**Customer Information Letter  
Medical Device Correction  
860306 Philips PageWriter TC30 Cardiograph**

**Blank I/O Module**

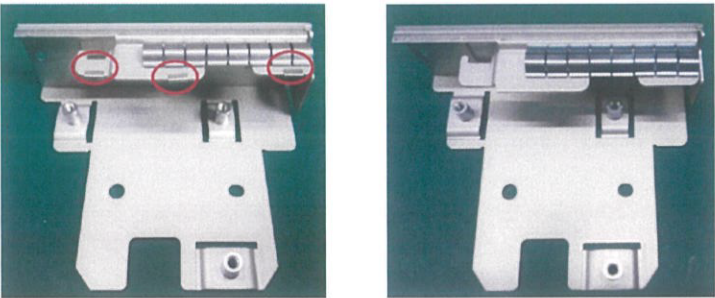
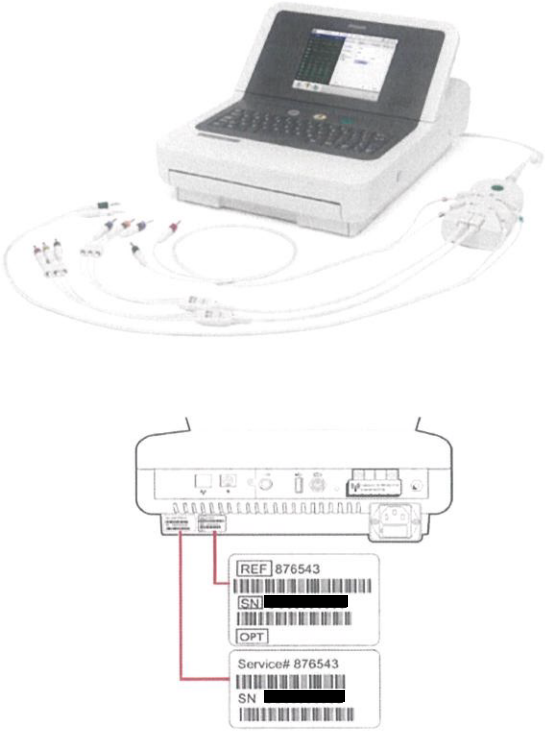
Philips has issued a correction to a manufacturing assembly problem for the 860306 Philips TC30 Cardiograph. Three additional non-functional ground springs on the Blank I/O module could become loose potentially leading to an internal short that could cause the cardiograph to stop working. As of today, we have not received any reports of these additional non-functional ground springs affecting the performance of the device.

<b>ADVICE ON ACTIONS BY CUSTOMER / USER</b>	Upon receipt of this notification, promptly locate your affected device.
<b>ACTIONS PLANNED BY PHILIPS</b>	Philips has issued a correction, free of charge. You will be contacted by a Philips representative to schedule an appointment to perform the removal of the additional non-functional ground springs from your Philips TC30 Cardiograph.
<b>FURTHER INFORMATION AND SUPPORT</b>	If you need any further information or support concerning this issue, please contact your local Philips representative: <Healthcare Representative/Modality Engineer: 1800-744-5477 or (Overseas Number)>
